RESOLUTION NO. 2018-13

RESOLUTION OF THE VILLAGE BOARD FOR THE VILLAGE OF CALEDONIA APPROVING THE AUDUBON ARBORETUM SUBDIVISION CONCEPT PLAN FOR PLAT REVISION – 5 ½ AND CHARLES ST., PARCEL ID'S 51-104-04-23-17-084-000, 51-104-04-23-17-085-000 & 51-104-04-23-17-086-005; AUDUBON PARK RACINE, LLC, OWNER

MEMORANDUM

Audubon Arboretum Concept Plan Revision

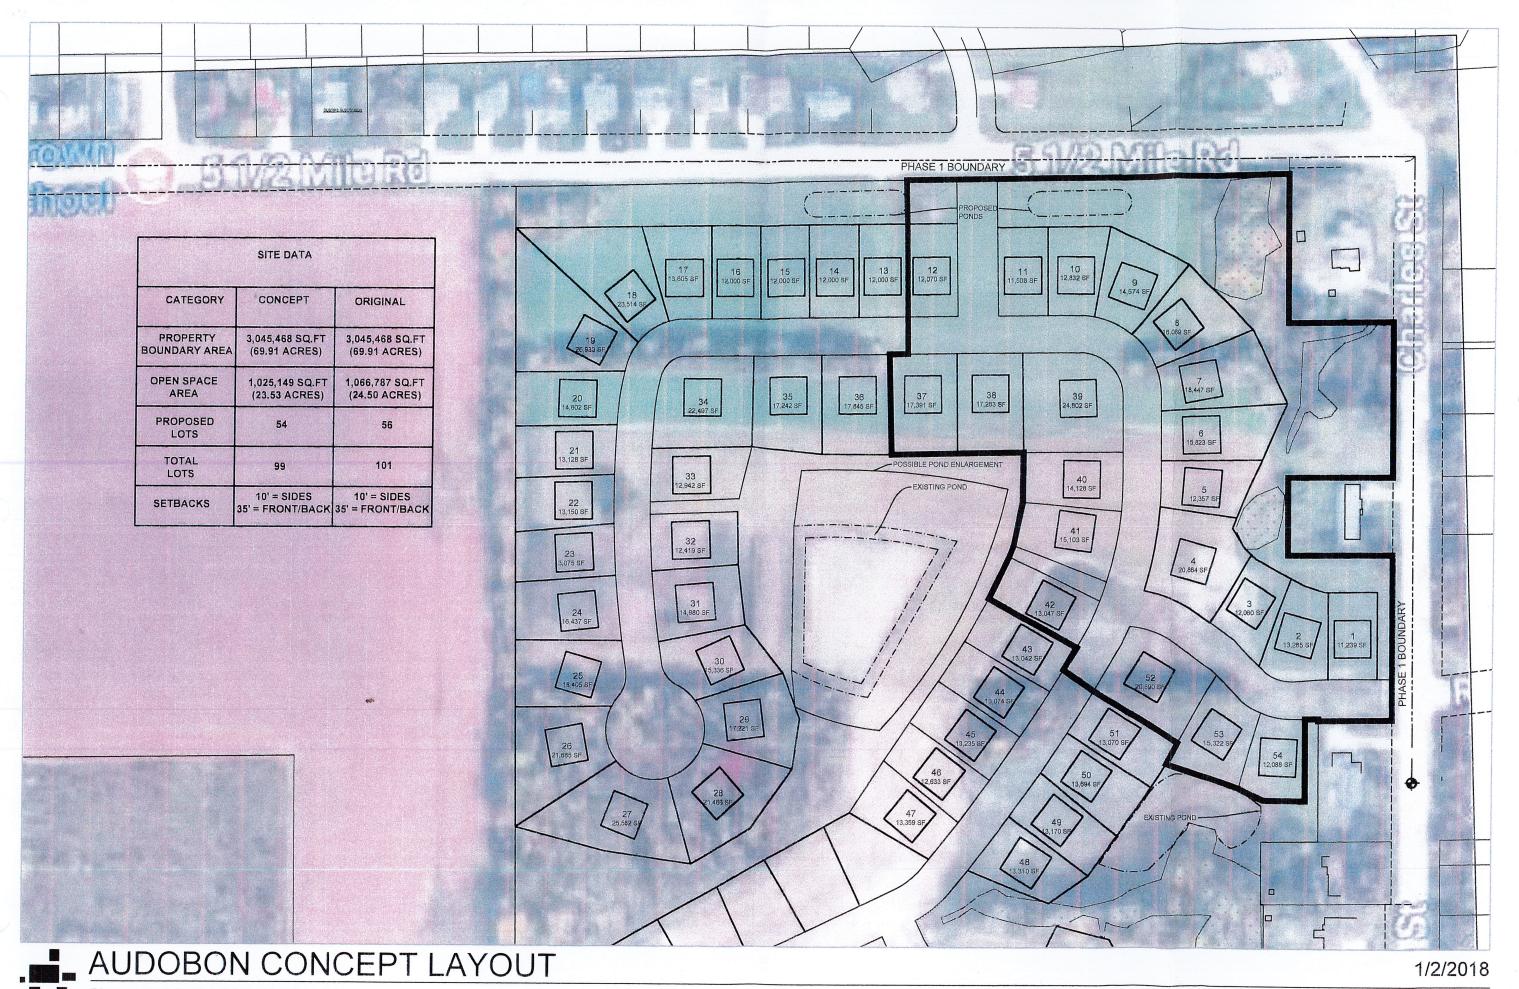
In regards to Waiver/Modification request #1, the Concept Plan for Audubon Arboretum is proposing a cul-de-sac roadway approximately 1,100 feet in length. The cul-de-sac is only

slightly longer than the maximum length and will be combining two, one-way roadways into one roadway, reducing pavement area that the Village will need to maintain.

In regards to Waiver/Modification request #2, the Concept Plan for Audubon Arboretum is proposing 36.5% open space for a subdivision within the Sewer Service Area. The Ordinance for Open Space in Subdivisions is currently under review with the Legislative & Licensing Committee. The Committee is looking to propose an Ordinance that does not require open space for Subdivisions within the Sewer Service Area that will be served with both Sanitary Sewer and Water. For Subdivisions that are located outside of the Sewer Service Area, the open space requirements would remain at 60%. The proposed Concept Plan, if recommended by the Plan Commission and approved by the Village Board, would still have open space incorporated within the subdivision.

- The approval of Waiver/Modification Requests #1 and #2 for Audubon Arboretum Subdivision at Preliminary Plat Stage.
- All comments from Racine County in regards to the Audubon Arboretum Concept Plan are addressed as necessary.
- The Audubon Arboretum Subdivision must conform to all Ordinances in Titles 9, 14, & 18 as necessary.
- The property has a R-3 PUD Zoning classification on it that allows the developer and Village flexibility with the layout and design of the subdivision.
- The Village is currently reviewing and may potentially revise Ordinance Title 14 Chapter 3 in regards to Subdivisions for Open Space and Conservation Easements.
